TITLE: A RESOLUTION OF THE MAYOR AND CITY COMMISSION OF THE CITY OF MIAMI BEACH, FLORIDA, APPROVING THE DESIGN FOR THE 41ST STREET CORRIDOR REVITALIZATION PROJECT, INCLUDING CERTAIN ADDITIONAL SCOPE ITEMS AS RECOMMENDED BY THE COMMUNITY, DESIGN REVIEW BOARD, AND THE MAYOR'S 41ST STREET BLUE RIBBON COMMITTEE, WITH ADDITIONAL FUNDING TO BE REQUESTED THROUGH THE FISCAL YEAR 2026 CAPITAL BUDGET PROCESS.

MIAMI BEACH 41 STREET CORRIDOR REVITALIZATION PROJECT

DESIGN REVIEW BOARD PRESENTATION
JULY 2, 2024

SUBJECT: **DRB24-1023 (FKA DRB23-0918)**
41st Street Right-of-Way Improvements

B-K LIGHTING
PALM TREE RING

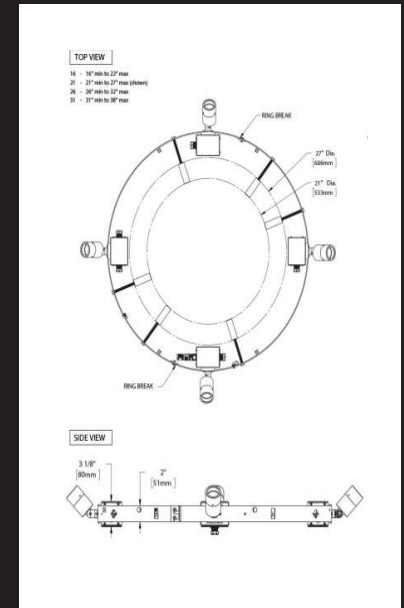
4. Wrapping of the palm trees with holiday lights was discouraged in favor of up lighting of the palm tree fronds.
5. Up lighting of the canopy trees was also supported, except for placing light fixtures within the canopy of the trees, as this can later result in health issues for the trees due to the required conduits and attachments.

1. Explore utilizing other bright colors (besides Miami Beach pink) for the canopy structures.
2. Miami Beach pink is acceptable for the sidewalk pavement and furniture that emerges from the sidewalk.
3. Miami Beach pink sidewalks should have the same branding features as the grey sidewalks.
4. Utilize the proposed canopy structures to provide shade
5. Utilize the proposed canopy structures to call attention to and embrace the palm trees or shade trees.
6. Option 2 regarding lighting (up and down light for every other Royal Palm tree) is recommended.
